Kansas Department of Agriculture
 Division of Water Resources
CHANGE: pu WORKSHEET

RE: Water Right, File Nos. 8345 AND 29229

CHANGE IN PLACE OF USE
FILE NO. 8345 & 29229

RE: Applications for Change in Place of Use
Water Right, File Nos. 8345 & 29229

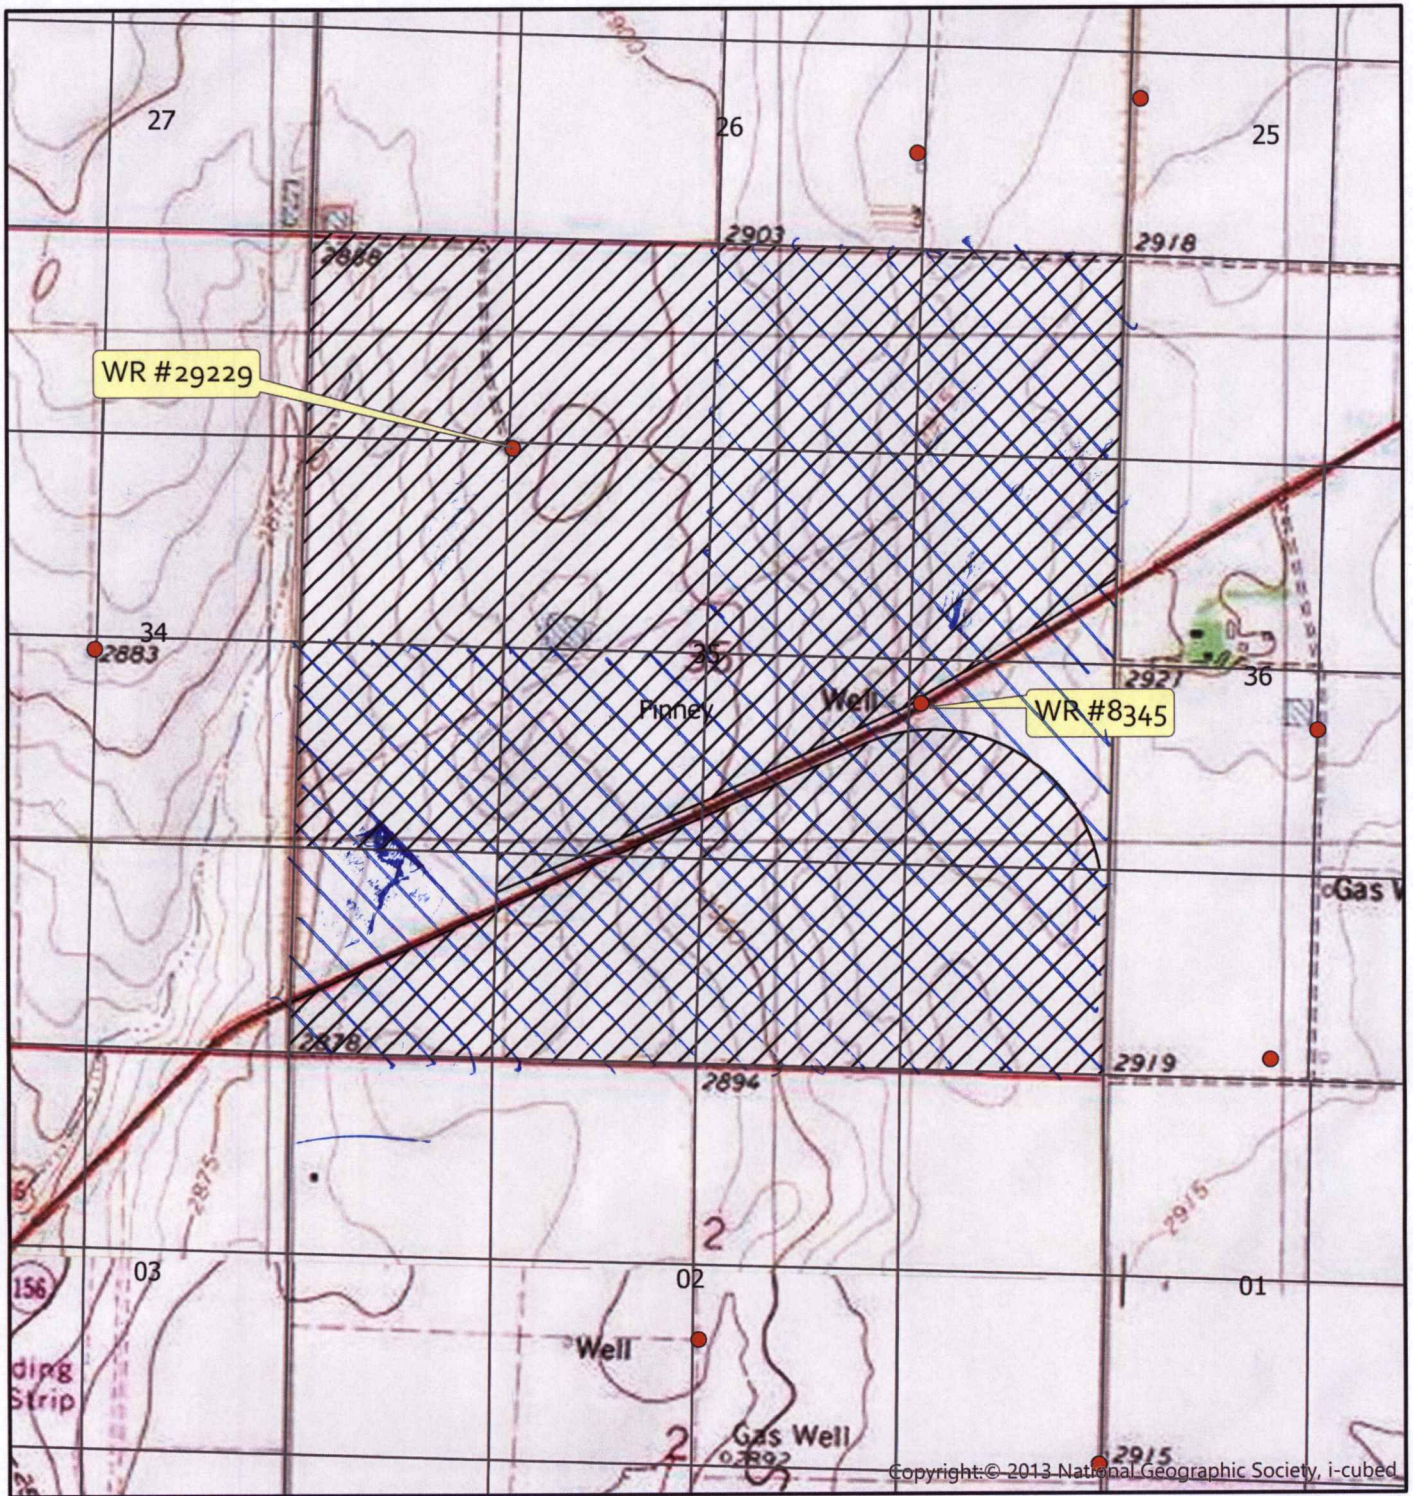
We have completed a review of the applications for the above referenced water rights. The proposals are not in conflict with the Management Program of the Southwest Kansas Groundwater Management District No. 3 (GMD3). The proposed change in place of use in irrigation acres is within the combined base acres for the water rights and will make a complete overlap, in accordance with K.A.R. 5-5-11. It is therefore recommended that the applications be approved at this time.

GMD3 Change Review

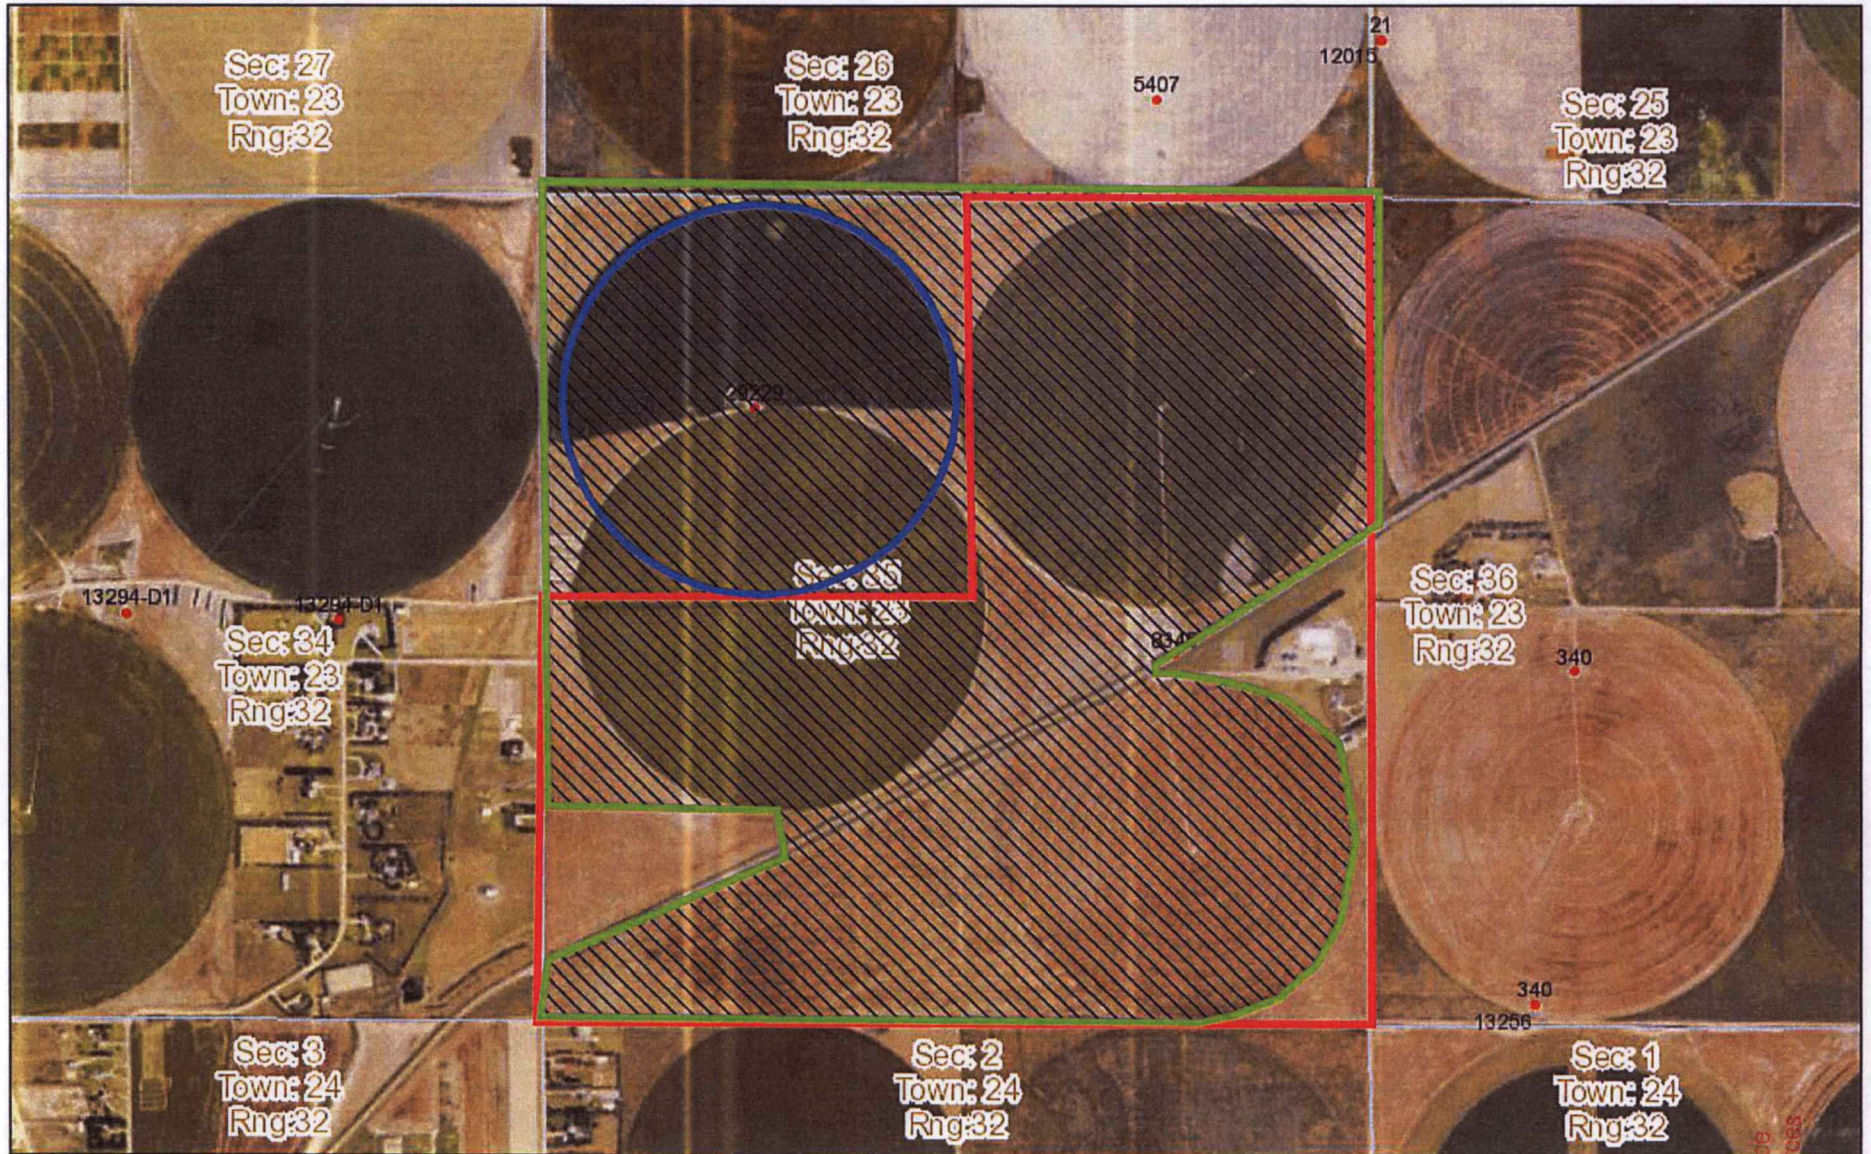
Is Proposed PU overlapping existing WRs? Overlapping these two WRs and redefining some of the acres.

Current acres: 463.6 (8345) + 136 (29229) = 599.6 acres

Requesting 585 acres (same as combined base acres)

Is a waiver needed: No, requesting within the rules for the base acres on the WRs.

Recommendation: After review of all available information, it appears all current area rules are met. The applicant is not increasing base acres. Staff therefore recommends approval of the applications.
